South Texas Project Electric Generating Station P.O. Box 289 Wadsworth, Texas 77483

December 21, 2010  
U7-C-STP-NRC-100274

South Texas Project  
Units 3 and 4  
Docket Nos. 52-012 and 52-013  
Supplemental Response to Request for Additional Information

RAI 03.07.01-27, Supplement 1

Figure 03.07.01-27.11 - 5% Damped Spectral Comparison in Y Direction at Top of Roof Slab (Corner away from access room), El. 30.0 ft

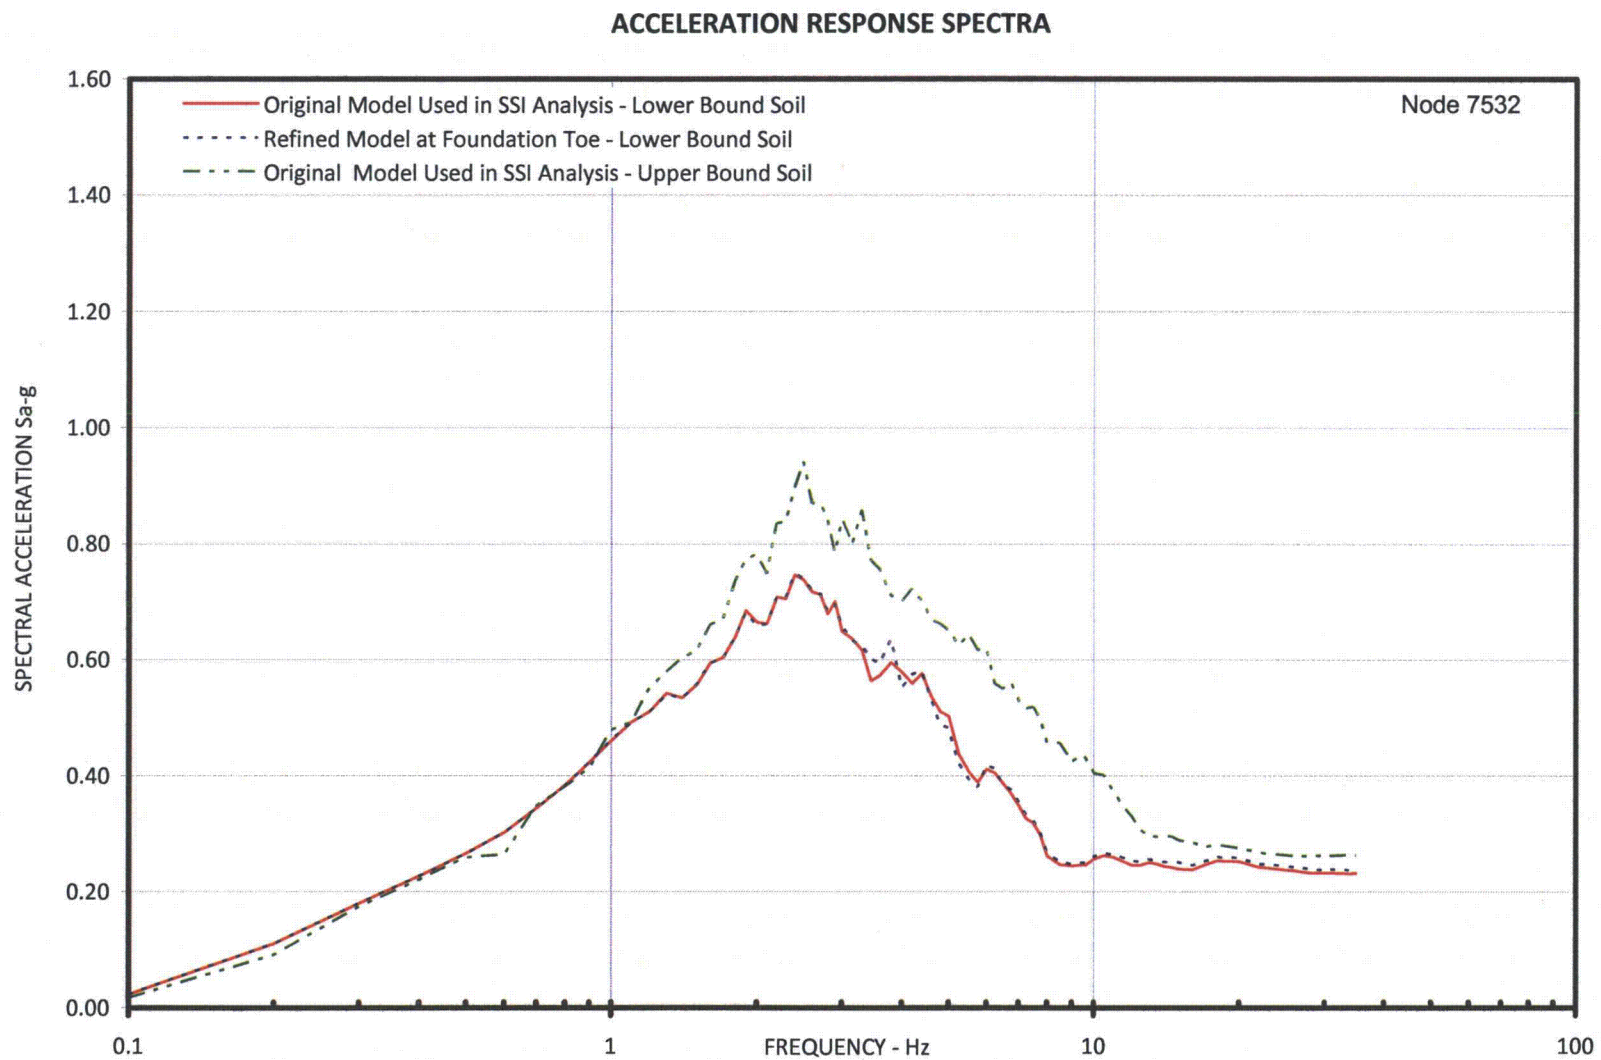
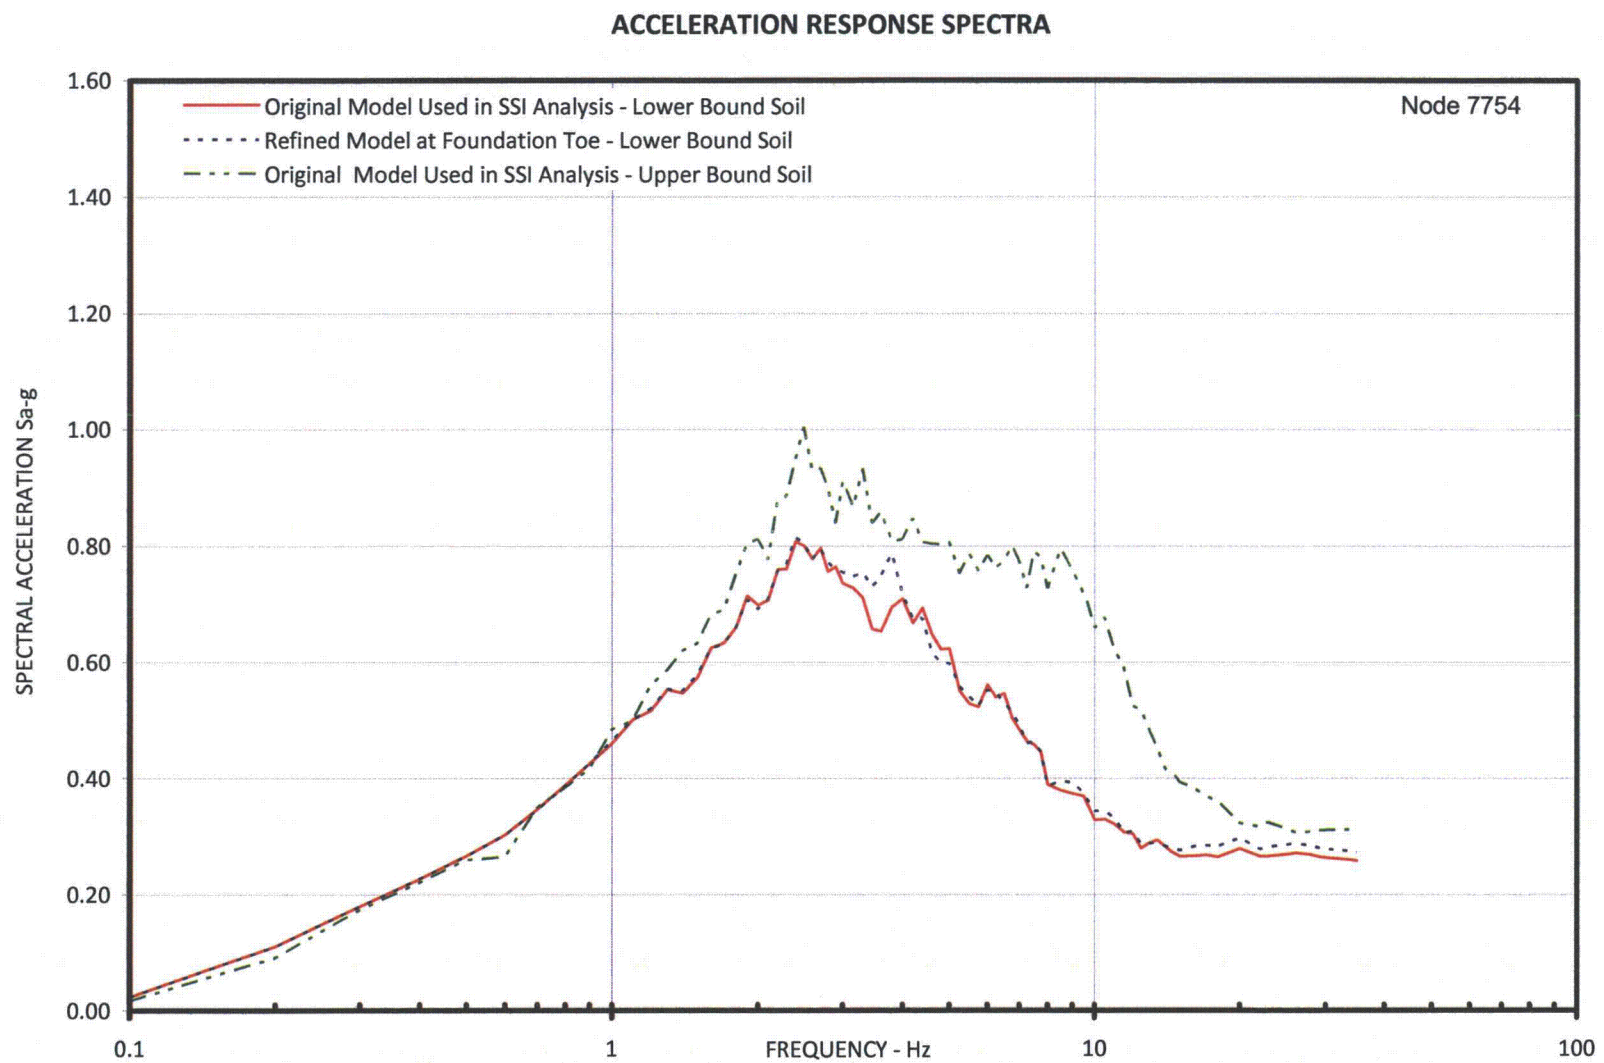
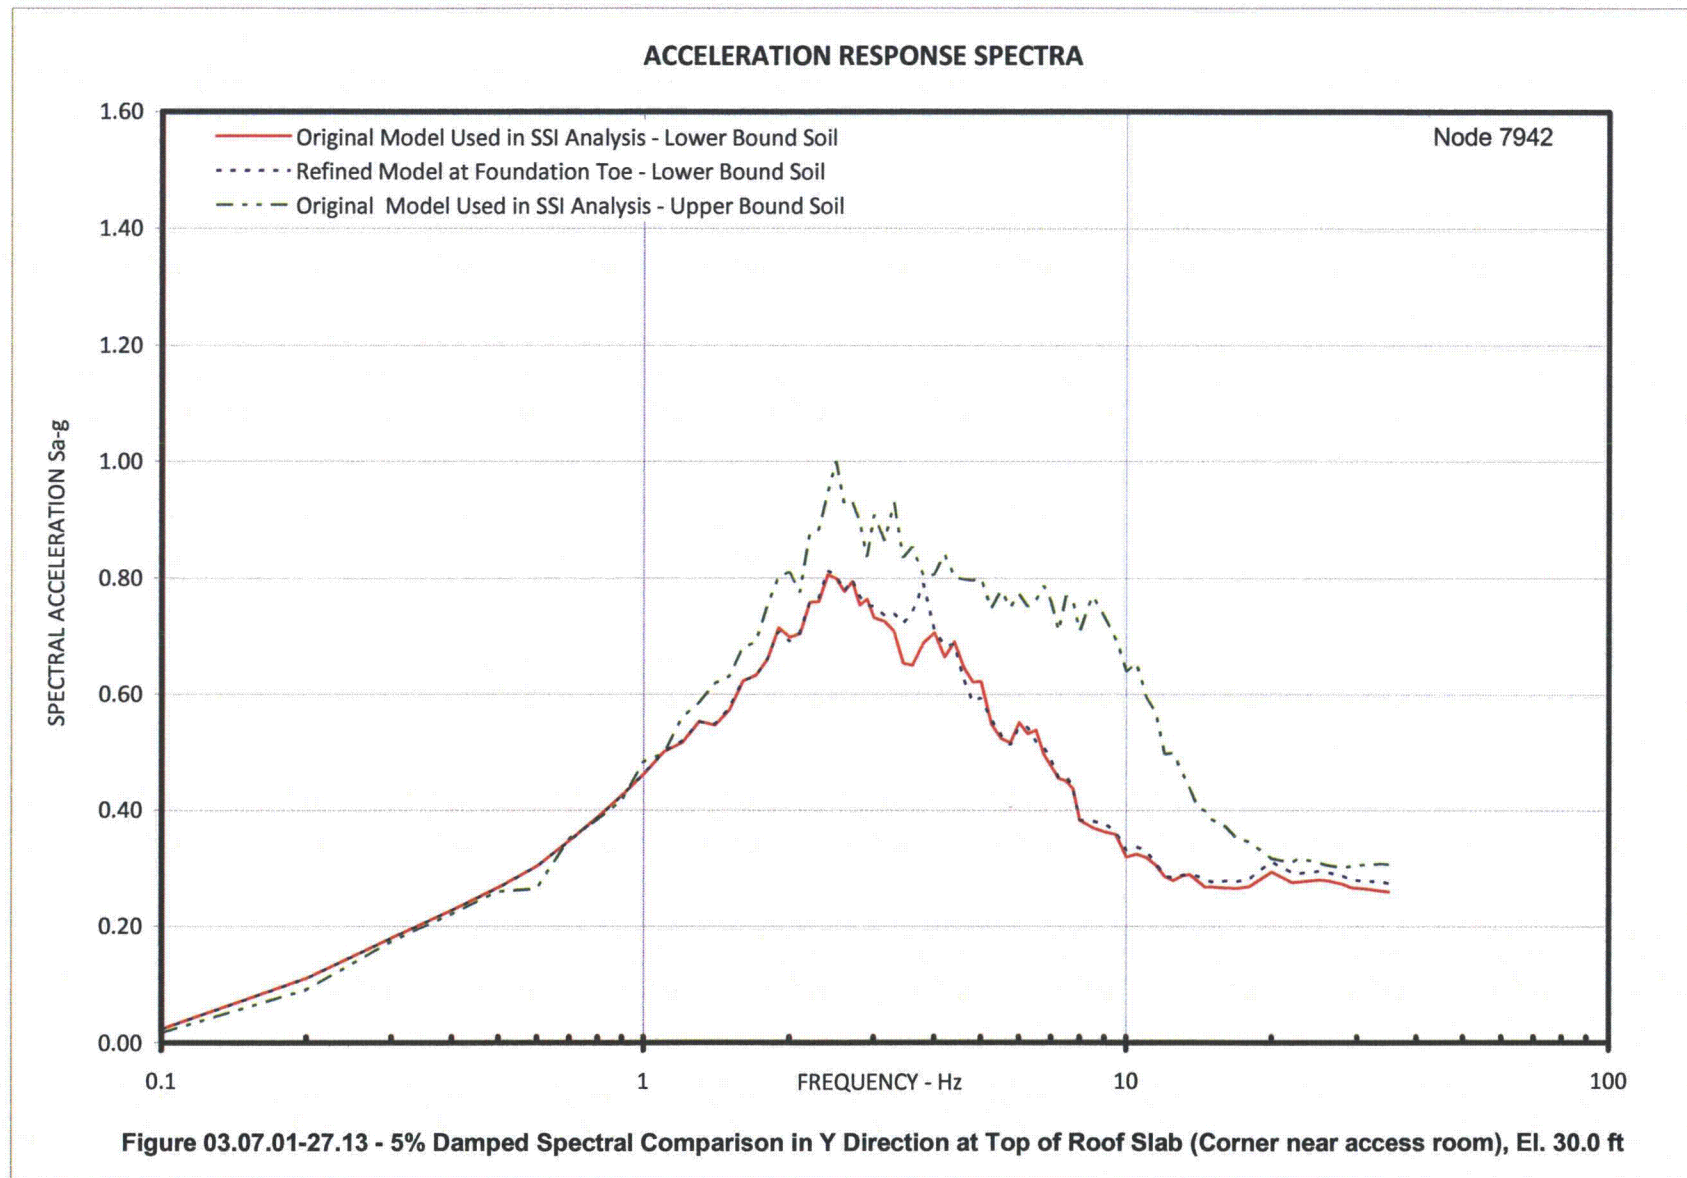
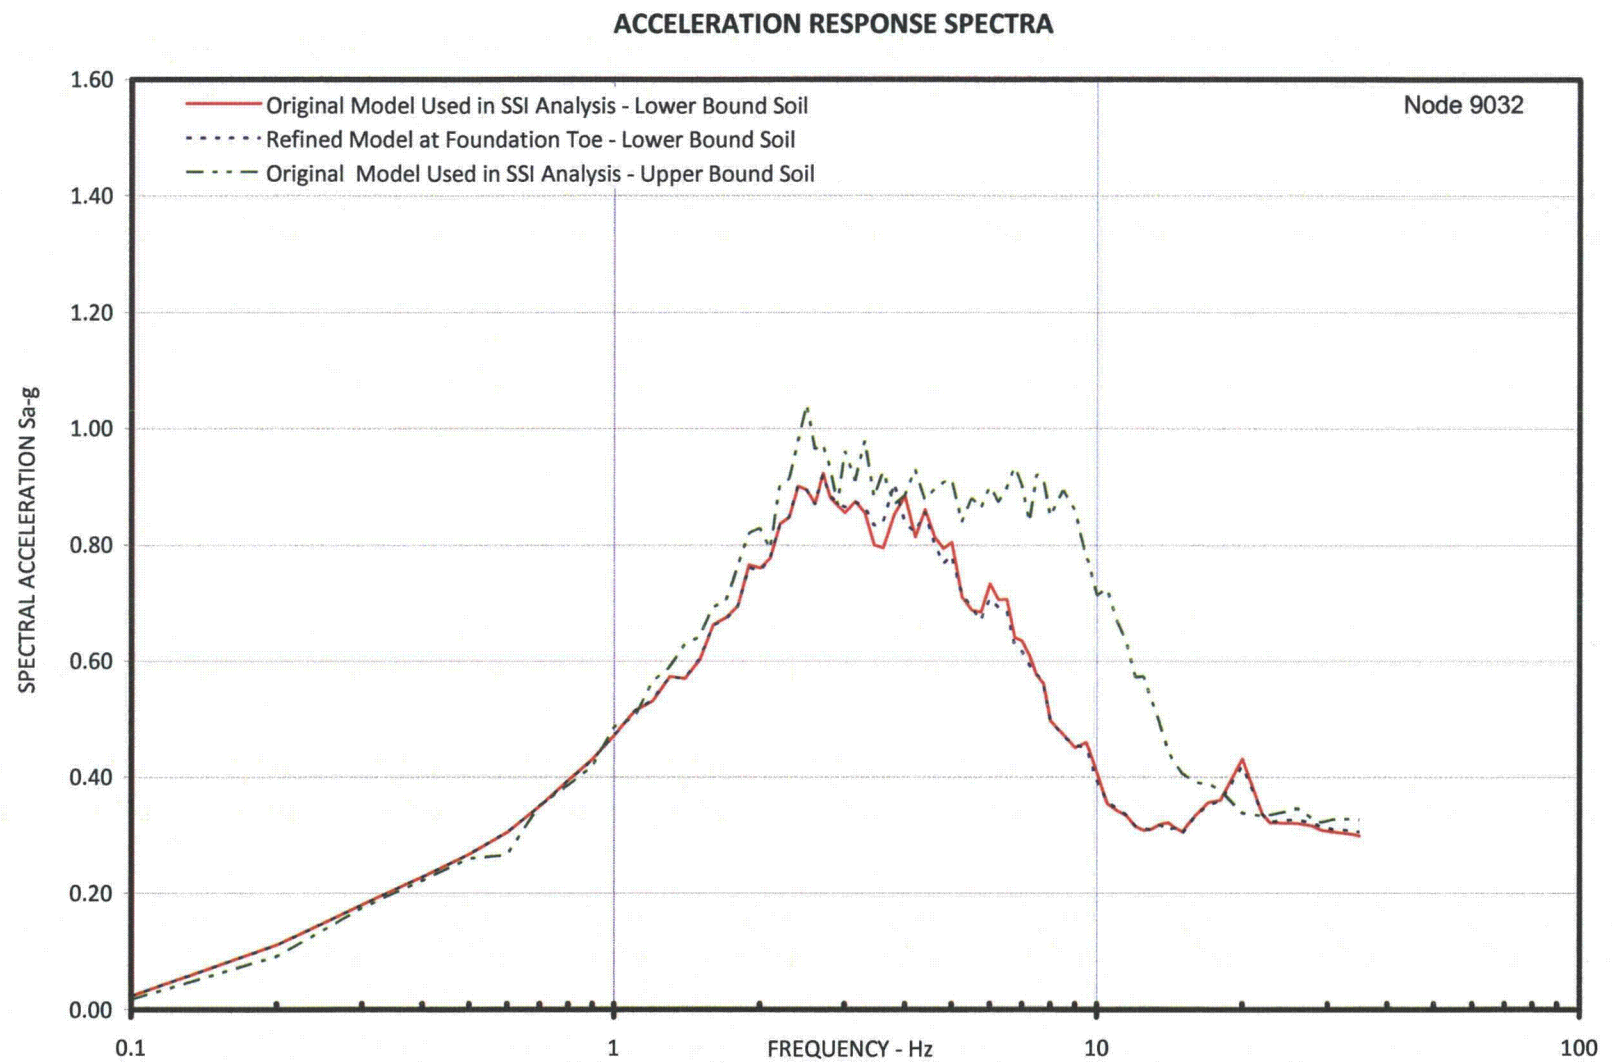
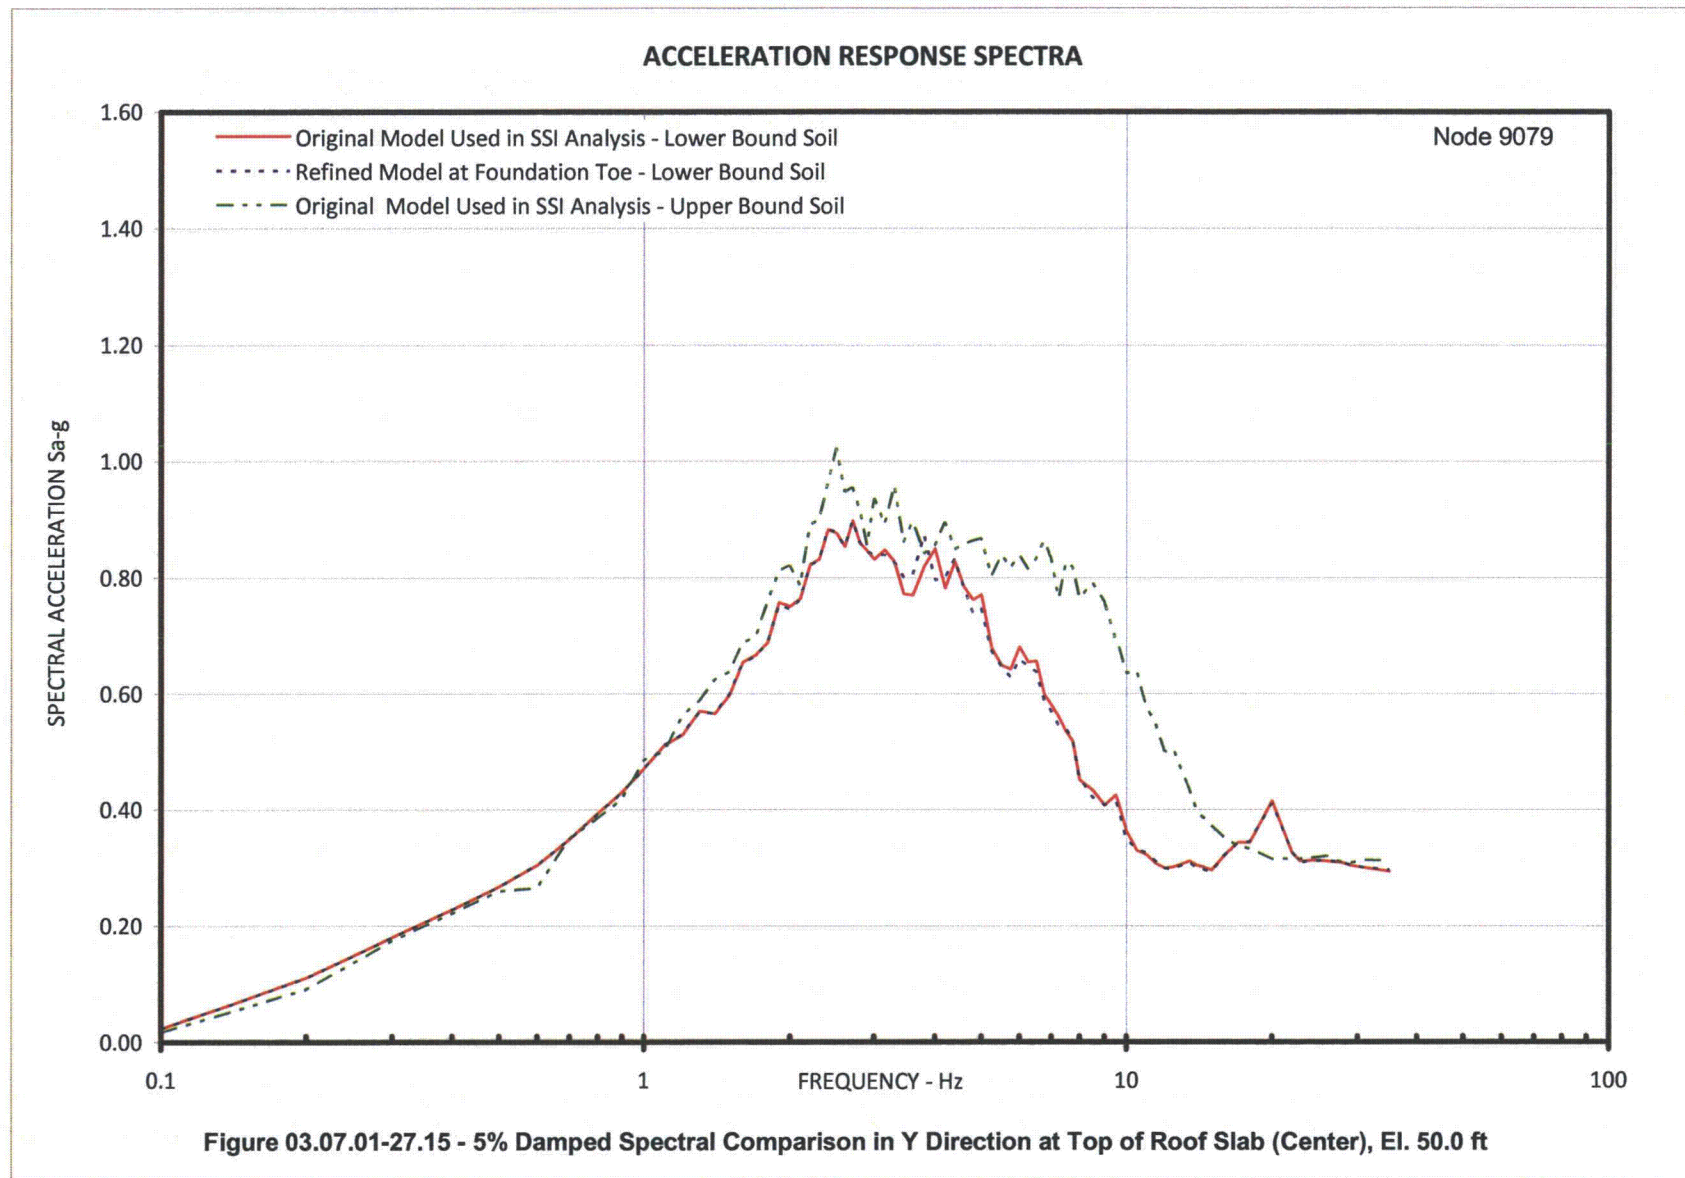
- (a) Describe in detail the method used for the SSI analysis of DGFOVS including the procedures for treatment of strain dependent backfill material properties in the model, input motion used and how it is specified in the analysis, variation of soil properties, and the computer programs used for SSI analysis.

To evaluate the effect of 20 Hz passing frequency for LB in-situ case, the foundation toe was divided into two elements, thus increasing the passing frequency to 40 Hz. This refined model with LB in-situ soil properties was analyzed and 5% damped spectra from this model were compared with the spectra from the original model with passing frequency of 20 Hz. The spectra comparison plots are shown in Figures 03.07.01-27.1 through 03.07.01-27.24. The comparison shows that:

- In the X direction, there is insignificant difference between the response spectra from the two models
- In the Y direction, the response spectra from the two models matched well except at frequency of about 3.8 Hz where the refined model produced higher spectra. However, spectra from both the models are enveloped by the spectra for UB in-situ soil case
- In the vertical direction, the spectra from the two models matched well (insignificant difference)

Based on the above evaluation it is concluded that the horizontal direction passing frequencies are acceptable.
